Illustrated Parts List - IPL Update

372 XP X-TORQ

1. Crank shaft assy.

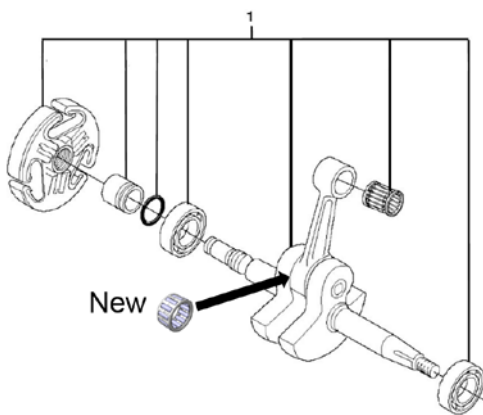
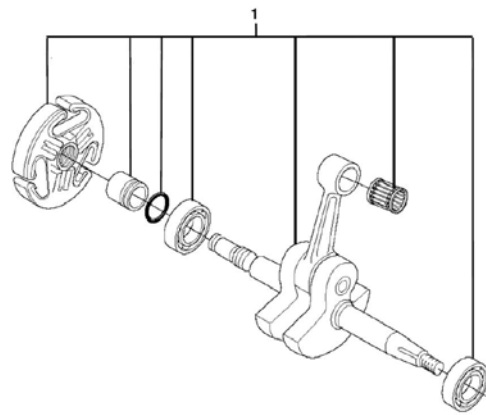
1. New crank shaft assy. with new big end bearing with a more robust cage.
2. New screw with torx grip T10 to knee joint, chip guard, cover, spike, chain guide, grounding cable and chain guide plate provides better condition for tightening.

503 74 87-05

503 74 87-04
